**Online Open House No. 2 Summary Report**

**Warden Avenue and Kennedy Road  
Environmental Assessment Studies between  
Major Mackenzie Drive and Elgin Mills Road in  
the City of Markham**

**The Regional Municipality of York  
17250 Yonge Street  
Newmarket ON L3Y 6Z1**

**May 2023  
300052314.0000**

# Preferred Design Concept - Kennedy Road - Intersections

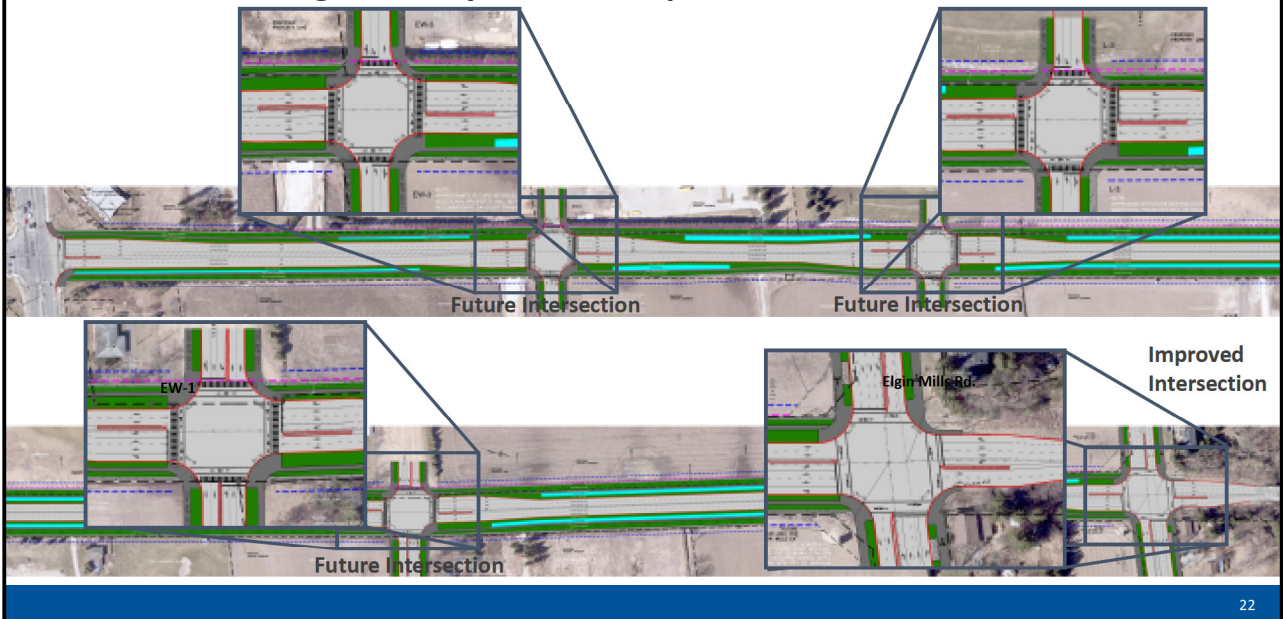
<p>Per Slides 20 and 22 of the Open House No. 2 package, the preferred intersection treatment at all five signalized intersections on each Warden Avenue and Kennedy Road is a “cross ride”. However, York Region’s Pedestrian and Cycling Planning and Design Guidelines (pages 110 to 114) discuss a preferred option; use of protected intersections with corner refuge islands. To</p>	<p>Acknowledged. The Project Team will evaluate each intersection and crossing details, balancing all user needs during the Detailed Design phase of the project.</p>

Comment	Response
quote from page 110, “The protected intersection is emerging in North America as a preferred higher order intersection treatment...” Please evaluate this concept at some or all signalized intersections.	
Although beyond the scope of this EA, York Region is encouraged to improve cycling facilities along other Regional roads and provide cycle lanes or cycle tracks, where absent. The Warden Avenue and Kennedy Road roll plans clearly illustrate glaringly absent cycling facilities beyond the EA Study Area.	The Project Team acknowledges this is beyond the scope of this EA. Connectivity and transition to existing facilities at the limits of the project is considered during Detailed Design, while also taking into consideration transition to future linkage opportunities recommended by York Region’s Transportation Master Plan and Pedestrian and Cycling Planning and Design Guidelines.
